Access Compliance Report

Public Rights-of-Way

(Curb Ramps)

Intersection ID: N/A	Main Street: E 7TH ST	Cross Street: N/A	Location: W
ADA ID: 81879E23474F	Ramp Type: Perp	Initial Pass/Fail: Fail	Overall Compliance: No
Codes/Mitigation Info/Possible Solution		Field Measurements/Component Compliance	
Severity Score: 12.5

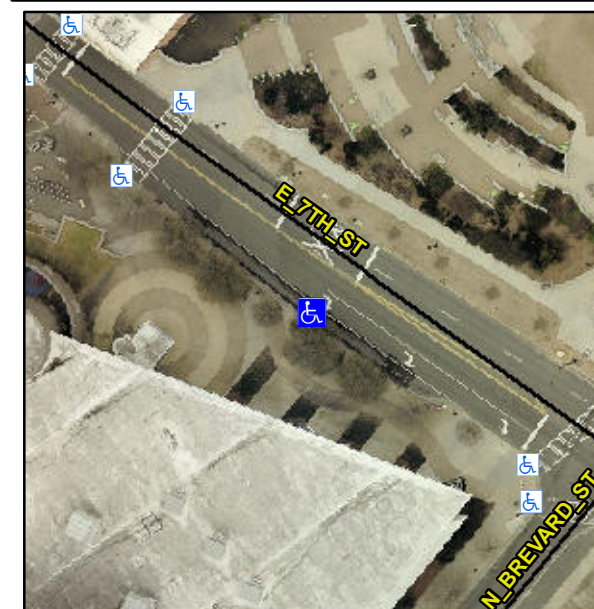
Not Found, R304.2.2

Compliance	Description	Data	Compliance	Description	Data
N/A	Ramp Length (in)	72.0	No	Ramp Slope (%)	8.6
Yes	Ramp Width (in)	58.0	Yes	Ramp XSlope (%)	1.2
N/A	Flare Type LT	N/A	N/A	Flare Type RT	N/A
N/A	Flare Slope LT (%)	N/A	N/A	Flare Slope RT (%)	N/A
N/A	Flare Traversable LT?	No	N/A	Flare Traversable RT?	No
N/A	Landing Length (in)	N/A	N/A	DWS Provided?	N/A
N/A	Landing Width (in)	N/A	N/A	DWS Contrast?	N/A
N/A	Landing Slope (%)	N/A	N/A	DWS Length (in)	N/A
N/A	Landing X Slope (%)	N/A	N/A	DWS Full Width?	N/A
N/A	Landing Curb? (Y/N)	N/A	N/A	DWS Offset (in)	N/A
N/A	Shared Landing?	N/A			
N/A	Gutter Ponding?	N/A	N/A	Gutter Slope (%)	N/A
N/A	Gutter Lip Ht (in)	N/A	N/A	Gutter X Slope (%)	N/A
N/A	Painted X Walk1?	No	N/A	Painted X Walk2?	N/A
	X Walk 1 Direction	To E		X Walk 2 Direction	N/A
N/A	X Walk 1 Width (in)	N/A	N/A	X Walk 2 Width (in)	N/A
	X Walk 1 Slope (%)	3.3		X Walk 2 Slope (%)	N/A
	X Walk 1 X Slope (%)	0.7		X Walk 2 X Slope (%)	N/A

Remove & Replace Entire Ramp.
